City of Portland, Maine – Building or Use Permit Application 389 Congress Street, 04101, Tel: (207) 874-8703, FAX: 874-8716

Location of Construction: 293 Read Street 04103		Owner: Michael Barriault Toby S. Rosenberg		Phone: 772-0491	Permit No: 990580
Owner Address: SAA	Lessee/Buyer's Name:		Phone:	Business Name:	
Contractor Name: Owner	Address:		Phone:		
Past Use: 1-Family	Proposed Use: Same	COST OF WORK: \$ 1,000	PERMIT FEE: \$ 25.00	INSPECTION: Use Group: R-3 Type: 5B BOC 096	
Proposed Project Description: Installation of Peachtree door, sliding patio door and vinyl replacement window, and wood floor of garage.		FIRE DEPT. <input type="checkbox"/> Approved <input type="checkbox"/> Denied		INSPECTION: Signature: <i>Hoffner</i>	
		Signature:		Signature:	
Permit Taken By: SP		Date Applied For: 6-3-99

BUILDING PERMIT REPORT

DATE: 5 June 99 ADDRESS: 293 Read ST. CBL: 150-D-003
 REASON FOR PERMIT: Installation of 2 door, window and Floor
 BUILDING OWNER: Barriault & Rosenberg
 PERMIT APPLICANT: _____ /Contractor Owner
 USE GROUP R-3 BOCA 1996 CONSTRUCTION TYPE 5B

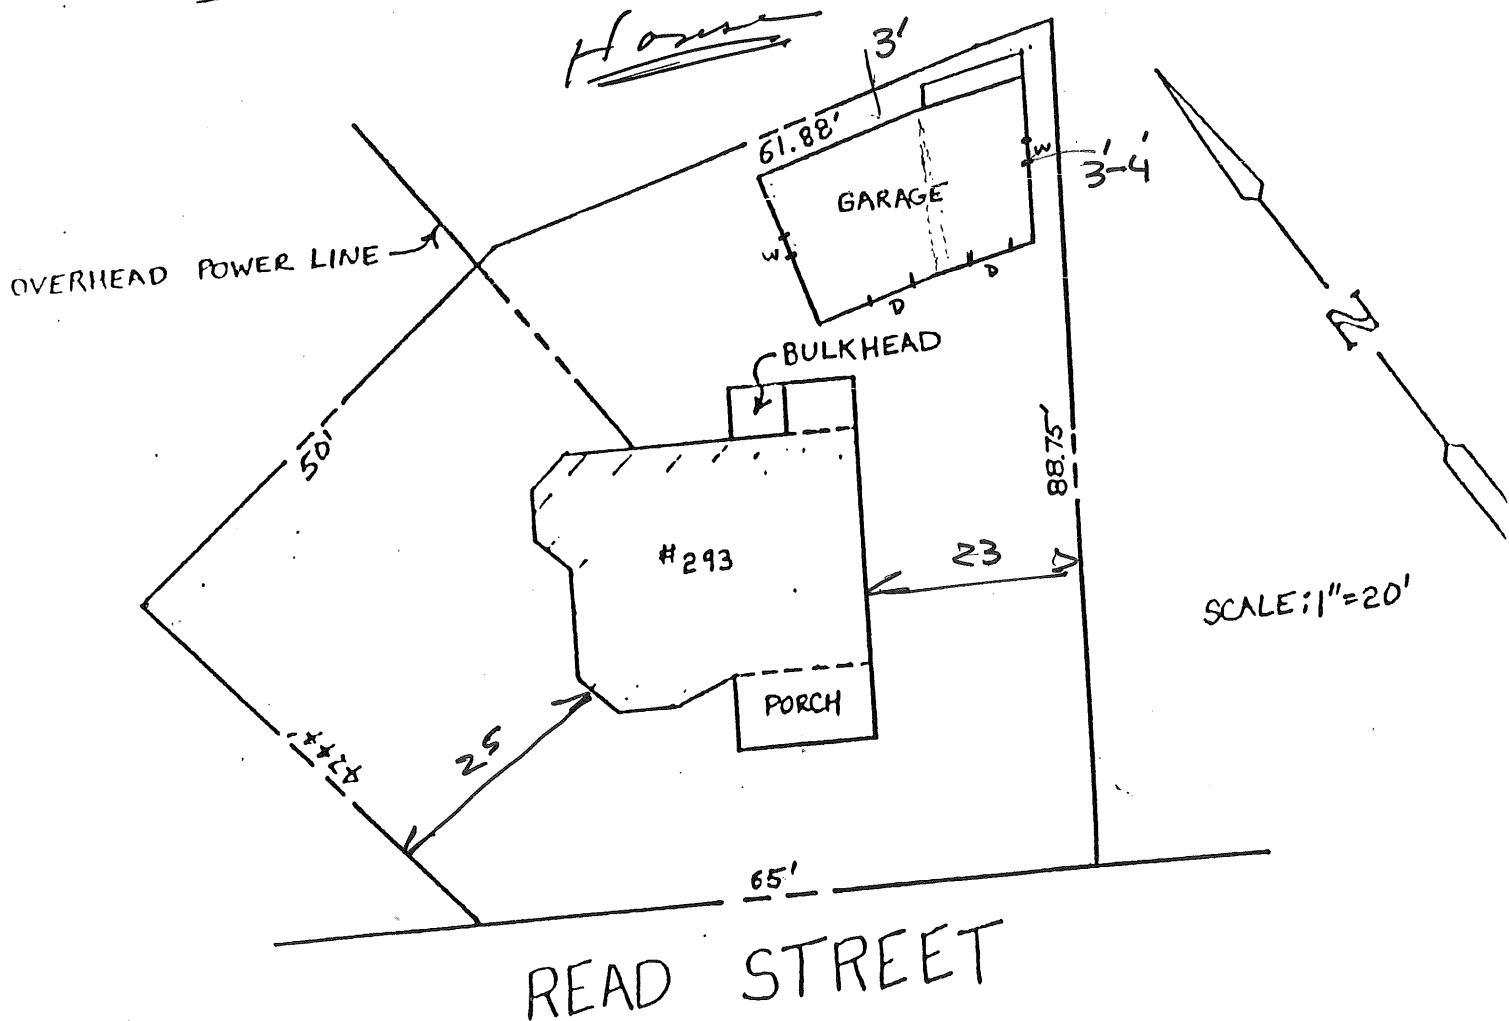
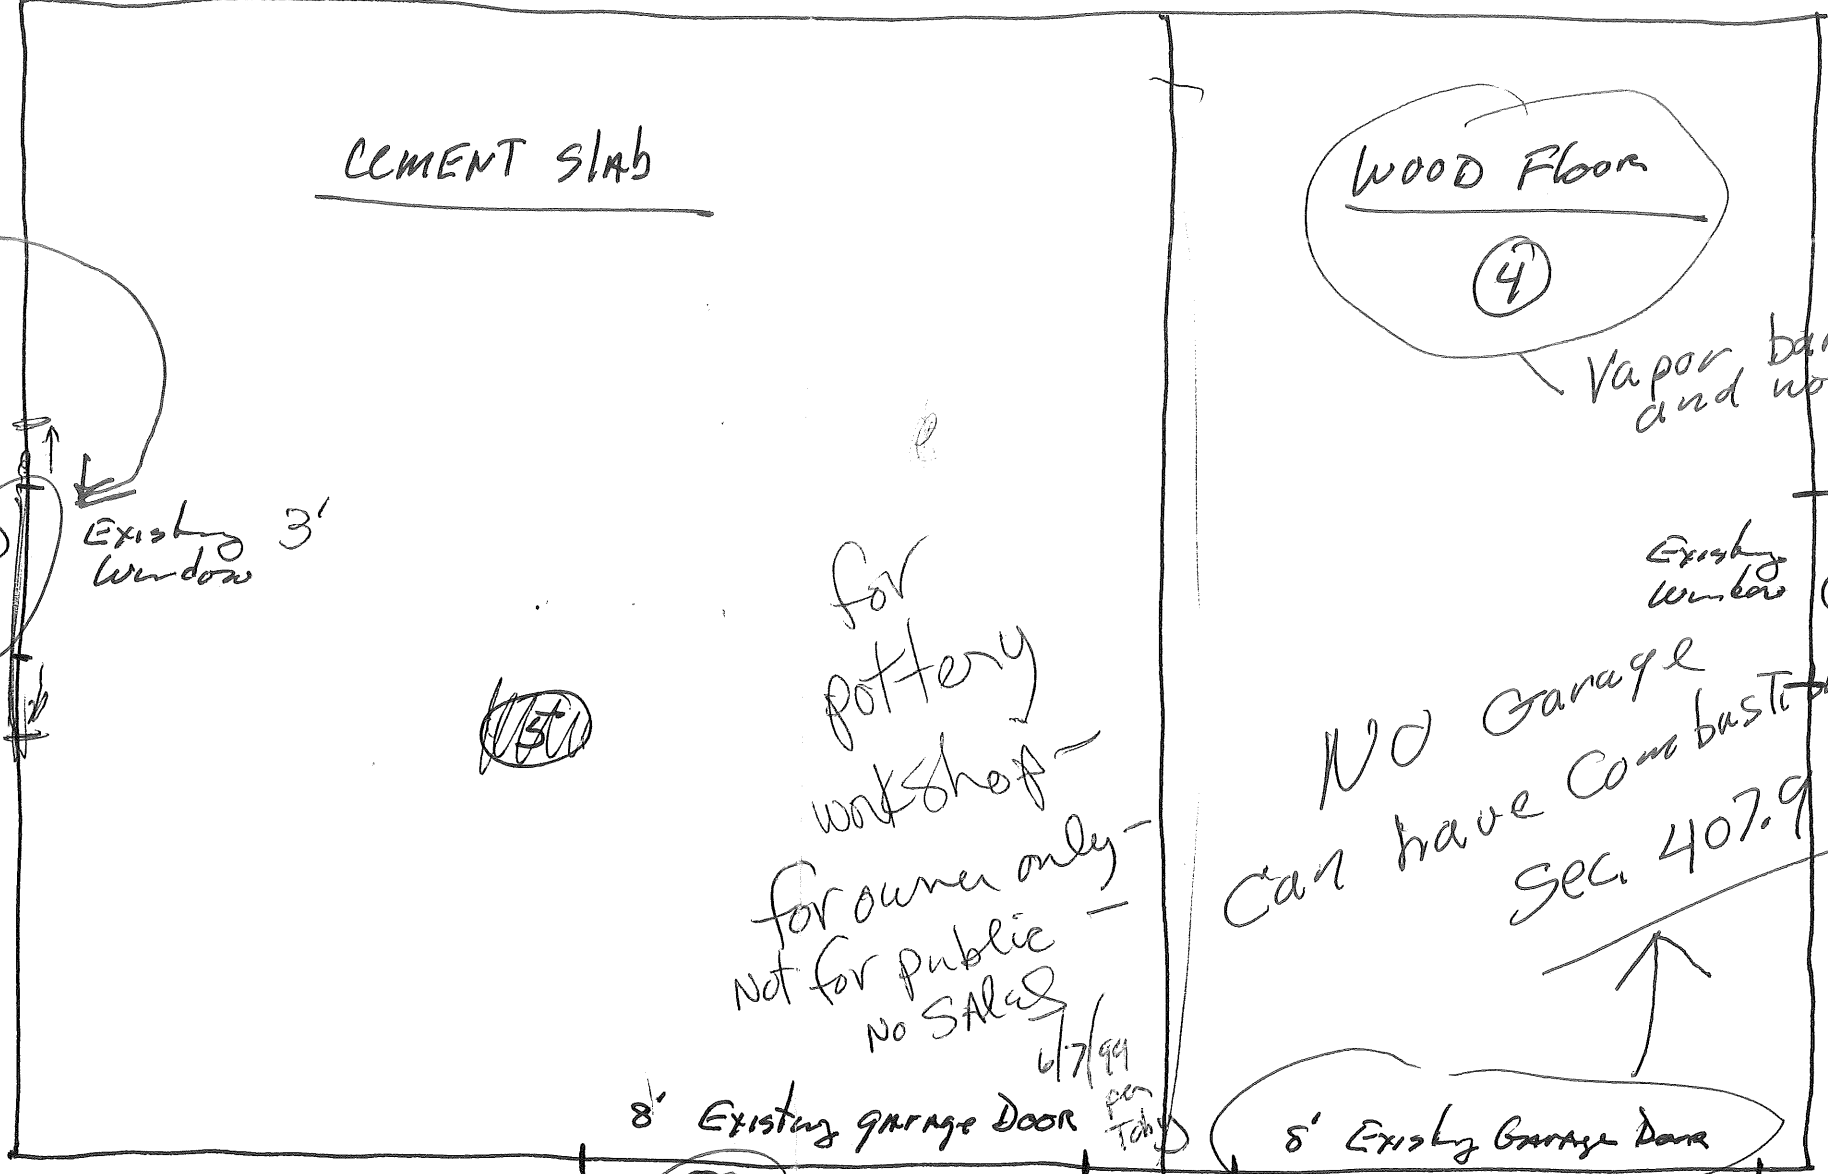
6/21/99 Met w/ contractor on site. I informed him that a piece of steel was required over the patio door, also that ceiling joints must be attached for support. They will not hold the weight of the sheetrock ceiling as they are. J R

34. *Your application plans did not show header size - 6' opening would require a minimum of 2-2x6 built-up header with spacer, double end -*

35. *8' span on eve side would require a minimum of 2-2x8" built-up header with spacer -*

NO Garage
Can have Combustible floor.
Sec. 407.9

① * install peachtree door 6'

② install sliding patio door 6'

① * 8' opening will be narrowed to accommodate 6' peachtree door

③ * Existing wall is just high enough 81" to allow sliding patio door to be placed in wall. Two x 4 side braces at the appropriate spacing will be install to enlarge the opening.
